March 18, 2024

IDEA Public Schools Electrical Switchgear Upgrades at Multiple Campuses CSP#22-ESGU-0424

ADDENDUM NO. 1

4

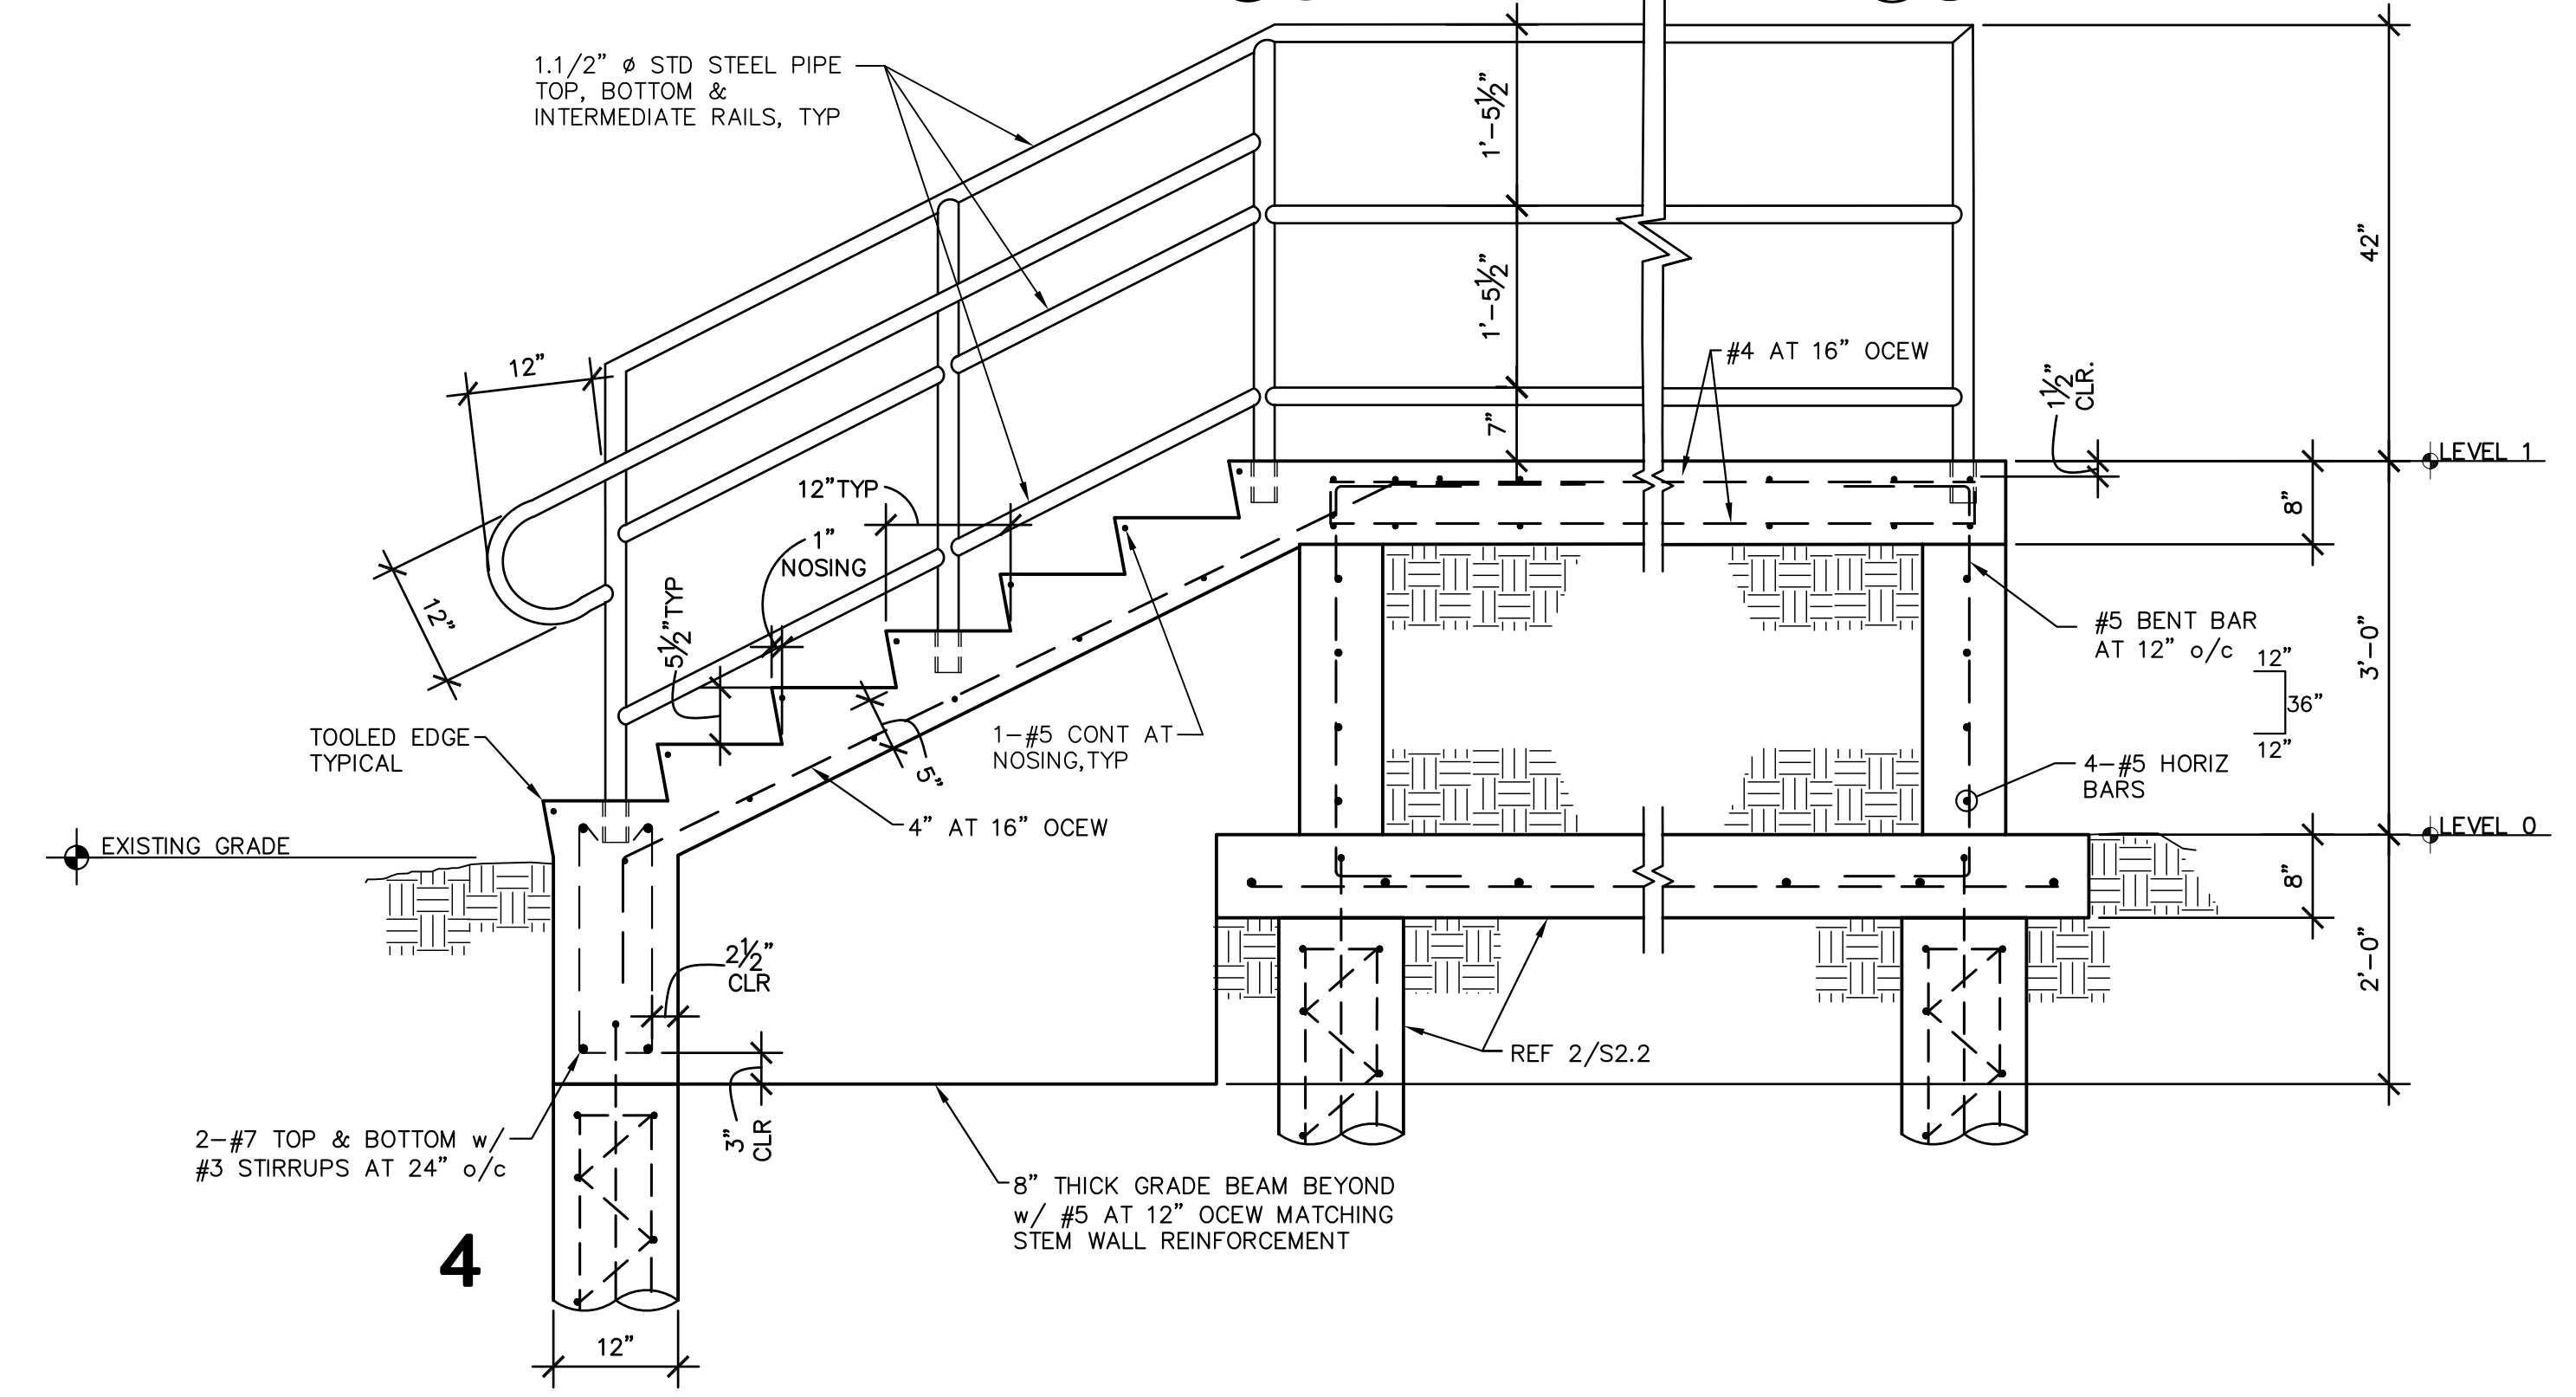
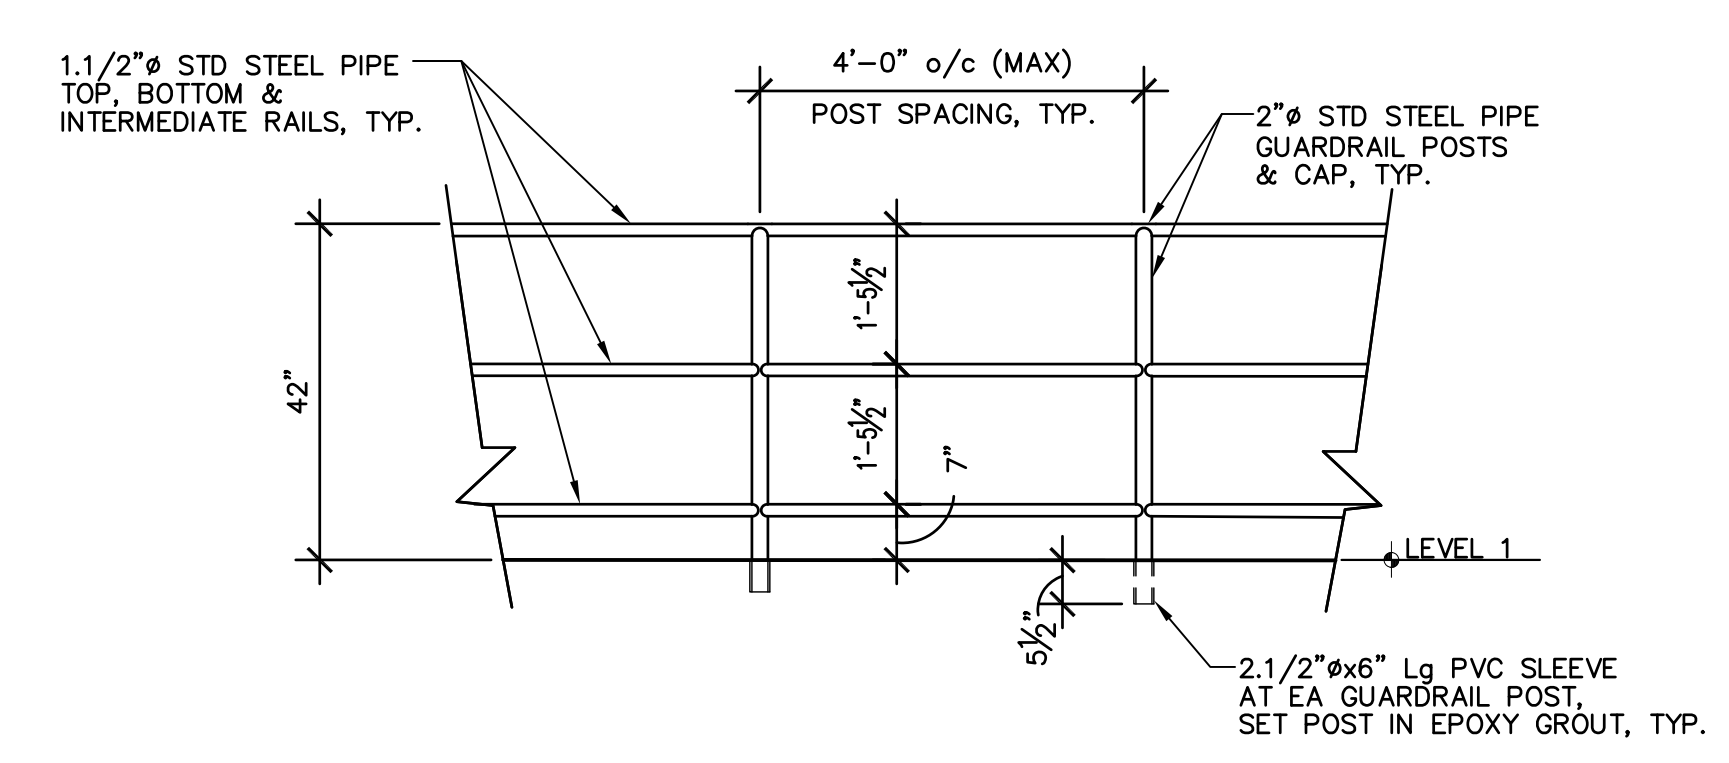
1. Cover:
 - a) Revised Executive Committee, Board of Directors, and Rio Grande Valley Regional Board. See attached sheet.
2. Sheet S1.1:
 - a) Added General Structural Notes. See attached sheet.
3. Sheet S2.1:
 - a) Added Structural Foundation Plan and Drilled Pier Profile. See attached sheet.
4. Sheet S2.2:
 - a) Added Structural Foundation Plan and Elevations. See attached Sheet.

- NOTES:
- COORDINATE FOUNDATION, STAIRS AND ORIENTATION WITH M.E.P SITE PLAN
 - * INDICATED DIMENSIONS THE CONTRACTOR WILL NEED TO FIELD VERIFY AND MATCH EXISTING TRANSFORMER CONDUIT BANK OPENING SIZE.
